Re: Consultation on the draft Concordia Basic Infrastructure Scheme

Basic Infrastructure Scheme

Summary of feedback from The Barossa Council

CONCORDIA INFRASTRUCTURE FUNDING PLAN TRANSPORT INVESTIGATIONS REVIEW

Figure 2 (page 8)

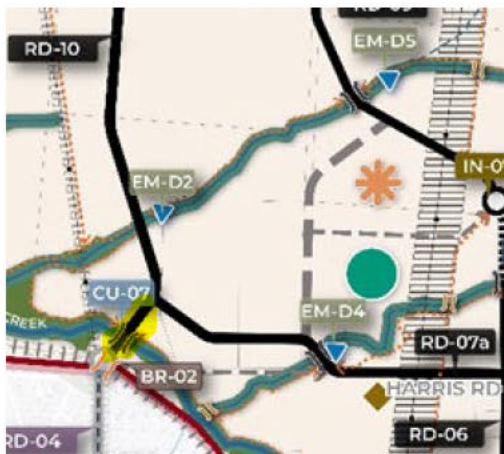
- Two "possible Connector Roads" are noted. Are these roads optional (i.e. replacing other connector roads), likely or unlikely? If required, are they to be solely delivered by the relevant developer at their expense or is some cost-sharing with a Charge appropriate?
- Query if IN-05 requires signalling at this junction?
- Seek detail on definition of 'stop/start' points (e.g. RD-10, RD-11, RD-08). There seems to be a gap for the short section of road between the junction of RD-10 and RD-07a and BR-02. This requires another label (e.g. RD-10a)

Refer image above: See yellow highlight

Figure 2: Cheek Avenue interventions (DHUD – Basic Infrastructure Scheme, 2025, p. 8)

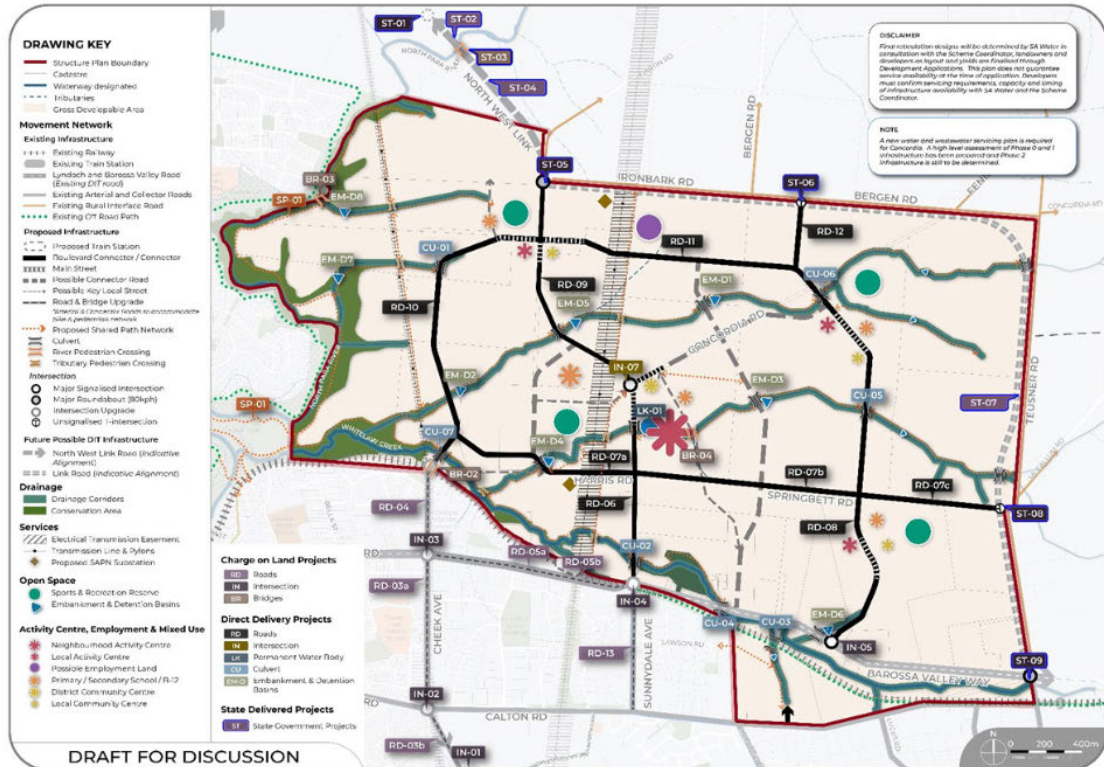
2. Co-ordinated delivery of infrastructure – A substantial package of road upgrades is proposed within the Town of Gawler – see Figure 1 and Figure 2. This approach is supported, noting that it reflects (a) the supplementary modelling and design work of AECOM; (b) the updated funding/cost plan at 5% design level provided by RLB; and (c) addresses the latest road design thinking by SPIIRE for the southern end of the Cheek Avenue corridor.

Figure 1 Staging misalignment

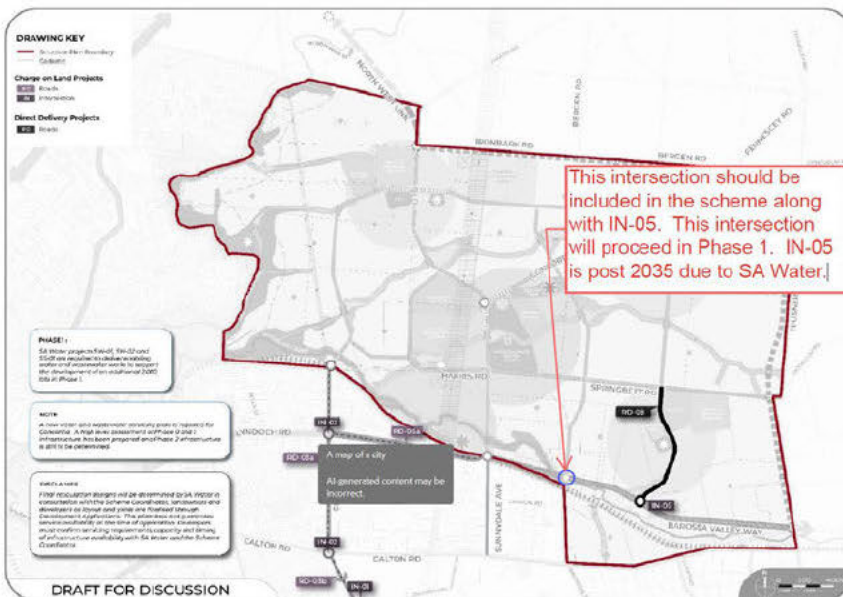
The proposed timing for the construction of IN05 Collector Road as part of Phase 1 does not align with the anticipated staging of the development. Metro Homes' development will not reach this point within the proposed timeframe due to SA Water timing (it is more likely to be post 2035). Further the intersection between Concordia Road and IN05 should be included in the Scheme as part of Phase 1 (see Figure 1).

- RD08 and IN05 will not be constructed in Phase 1 due to no SA Water supply in this location post 2035 (refer to Table 18: Phase 1 Infrastructure Projects).
- A new intersection should be included in the scheme (IN-Metro) to be 100% apportioned to the Concordia Growth Area, and a new road be included as Direct Delivery to replace RD08.
- IN05 should remain in the Scheme with 100% apportioned to the Concordia Growth Area but at a time post 2035. RD08 should also be post 2035.

Figure 1 - Overlay of approximate extent of a conformant roundabout on high-level sketch (After DHUD, 2025)

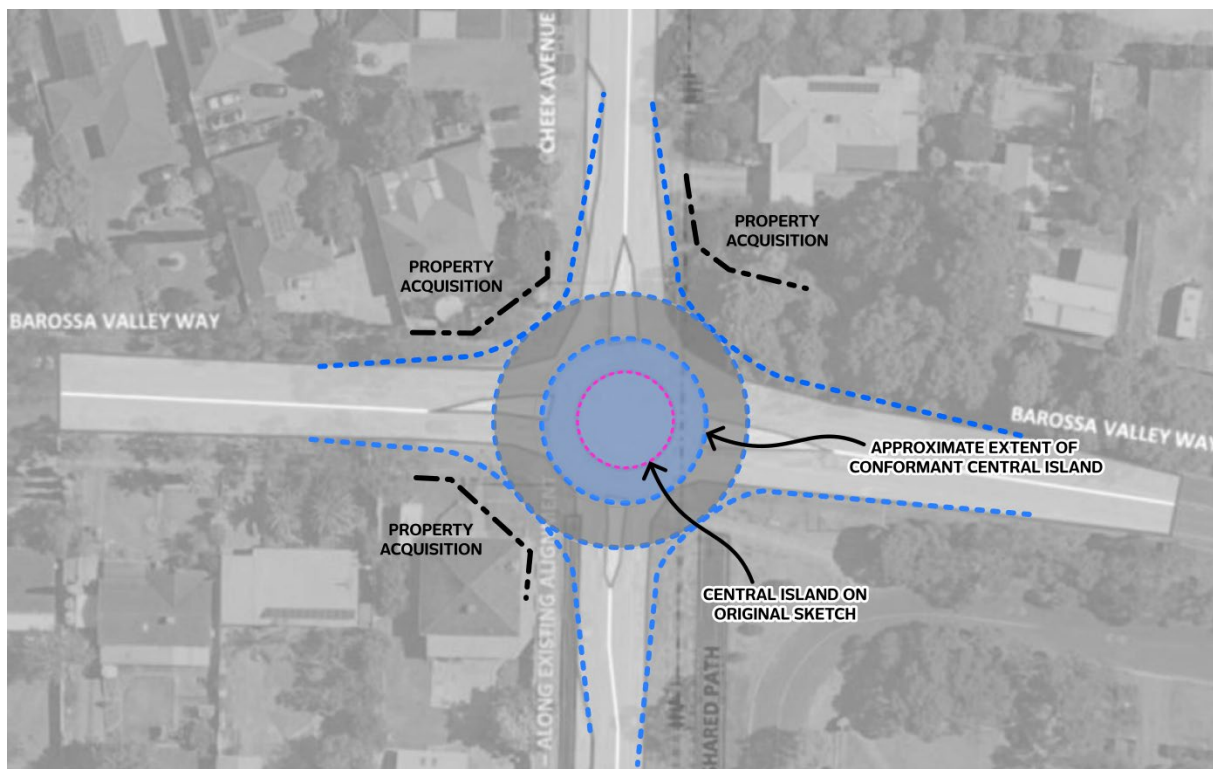
Achieving the relevant design criteria would result in a roundabout with an extent approximately 67% larger than that identified on the sketch. For comparison, Figure 1 illustrates the approximate extent of a conformant roundabout (based on 60 km/h design speed).

As can be seen in Figure 1, a conformant roundabout would have property acquisition requirements on three corners. It is unclear if the costings for the 'Before Concordia' scenario have allowed for such acquisition (or the overall larger roundabout size likely required).

Figure 2 *Transport Infrastructure Staging from page 82 of the Concordia Transport Infrastructure Strategy prepared by AECOM*

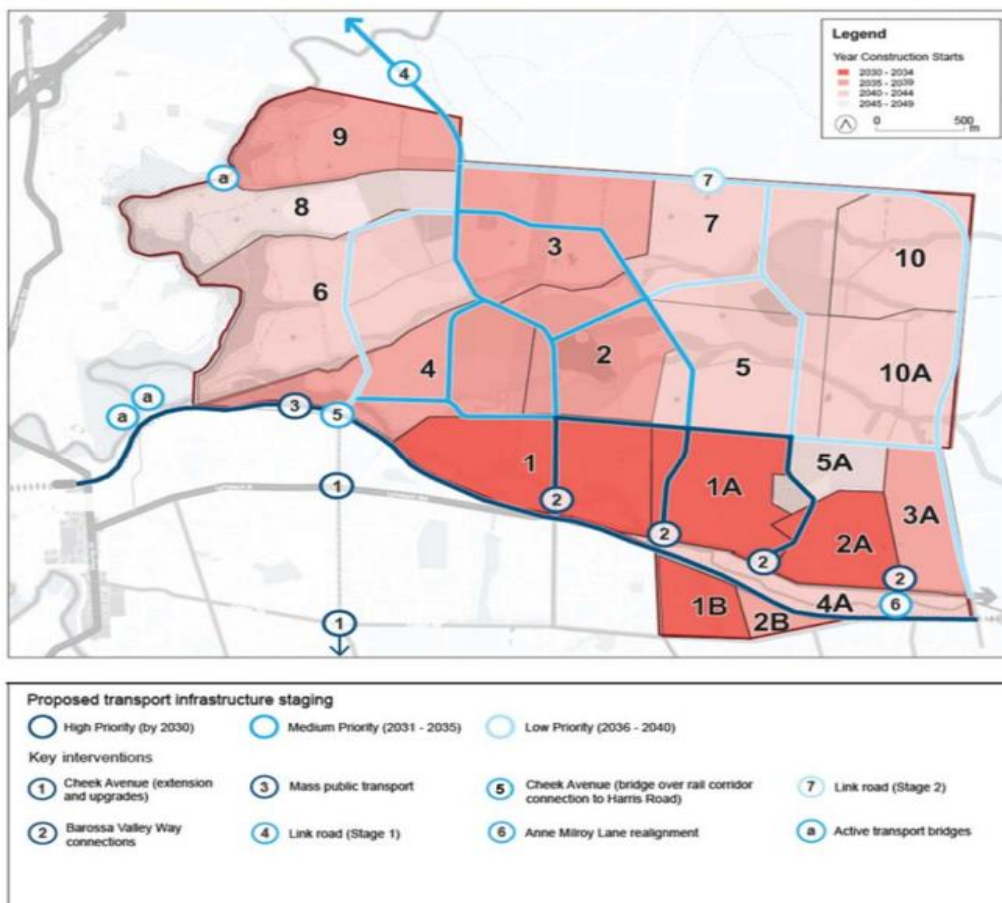
A solution to enabling development across more of the CGA is delivery of enabling infrastructure. In this regard, **the Stage 2 link road identified as 7 in Figure 2 below should be delivered sooner as it represents key infrastructure that would unlock Meland’s and other land in the CGA.** The link road is not currently scheduled for delivery until Phase 2, however if delivery of the link road was scheduled earlier it would create the potential to facilitate development of stages 3, 7, 5, 10 and 10A (as identified in Figure 2) and multiple growth fronts across the CGA.

We note that the AECOM report suggests that there is an opportunity for the Link Road to be initially constructed as single carriageway providing one lane in each direction. We suggest that this approach be adopted to assist in facilitating the early delivery of this infrastructure.
